**RE: Botany Aquatic Centre Redevelopment
Response to RFI's**

A Development Application (DA-2024/50) was lodged with Bayside City Council (Council) for the proposed redevelopment of the Botany Aquatic Centre located at Myrtle Street, Botany. The proposal incorporates new indoor and outdoor pool and leisure facilities, a gymnasium, amenities and change rooms and a café.

Stantec was engaged to prepare a Transport Impact Assessment (TIA) to support the DA which was completed in February 2024¹.

Figure 1: Number of visits each month September 2023 to April 2024

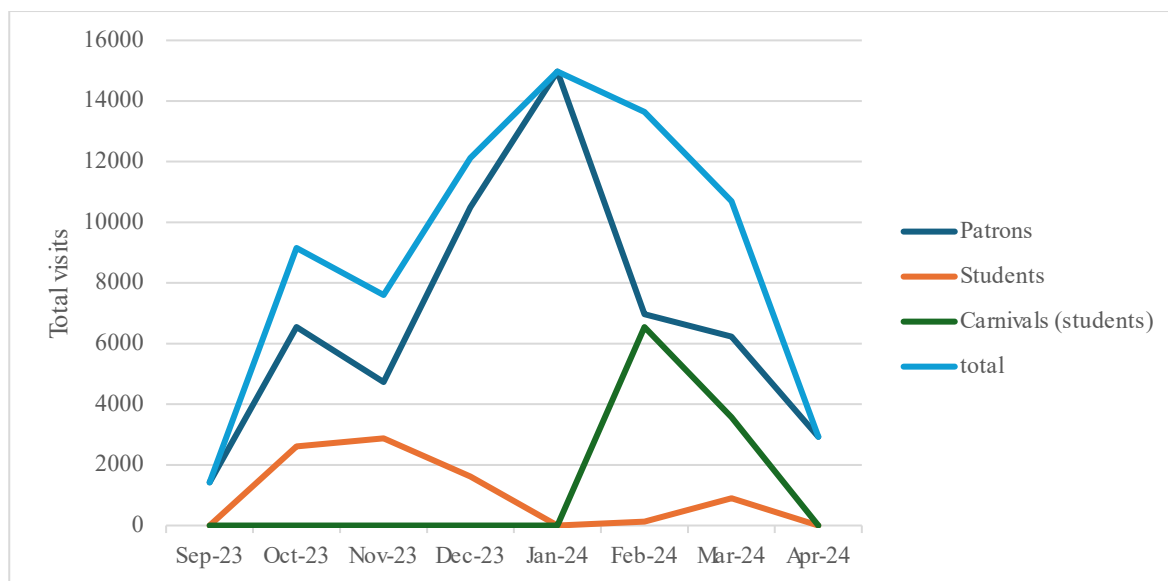
Comment 1 (a) - The traffic survey in section 2.6 of the traffic report prepared by Stantec provides insufficient survey data. It is noted that the survey was not completed during the busiest months of an aquatic centre (survey must be undertaken during peak summer periods), water slides were removed for 80% of the surveys and the surveys were of an old aquatic centre at the end of life. Hence, these issues indicate that this survey data is not sufficient to rely on for the traffic and parking assessment, a summer survey needs to be undertaken of a new aquatic centre in a similar locality with a similar offering to the development to understand peak car parking demands.

Stantec's response - As noted above it has not been possible to identify another new site with a similar offering of services to that proposed at the Botany Aquatic Centre. Furthermore, undertaking a new survey during the peak summer period (which is still some 2-3 months away) is not practicable at the current time of preparing this response. In lieu of these considerations, patronage data has been obtained from Council for the Botany Aquatic Centre for the period extending from September 2023 to April 2024 which includes the most recent summer peak period. A summary of this data is shown below along with the estimated average daily parking demand.

Figure 1 demonstrates that attendance at the centre peaks between January and March, which occurs as a result of a peak in school carnival activity that occurred during this time. In February and the beginning of March, 26 carnivals occurred with over 10,000 students over the two month period. Most of these students arrived via bus/coach or via parent pick-up/ drop-off.

As expected, **Figure 1** demonstrates that attendance peaks during the summer seasons, with dips in attendance during the winter seasons. The lowest attendance was recorded during September with 1,422 patrons.

As for special events such as carnivals, it is assumed that most students are either dropped off by parents/ carers or buses. As seen in Figure 1, students attending carnivals peak in February with a total of 6,545 students, this is equivalent to 234 students per day. Based on an occupancy of 36 students per bus, there will be around 7 buses per day during the peak carnival period. The buses will utilise the existing bus loop and will not be permitted to stay on site. Considering buses will utilise the bus loop and will only be present for short periods of time to pick up and drop off students, it is not expected that they will impact the parking demand.
